**Report: REVIVE REPORT
Function: Test, Adjust, & Balance
Date: 03/10/2023**

**02-20-23 FREDDY'S - MCDONOUGH, GA
(REVIVE)**

Issue Name : 05 - ACSPS is dirty

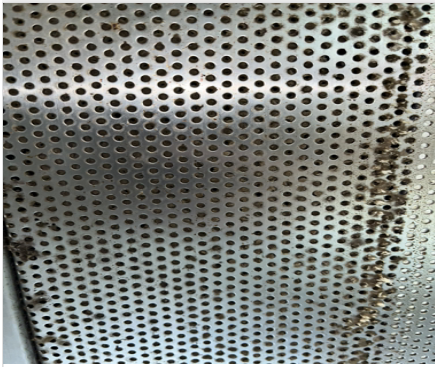
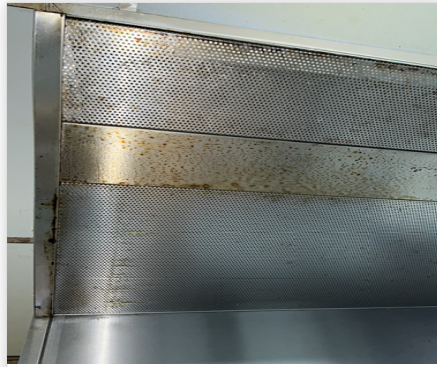
Description : Recommend dropping the AC-ssp portion and cleaning the top and bottom of the perforated grilles.
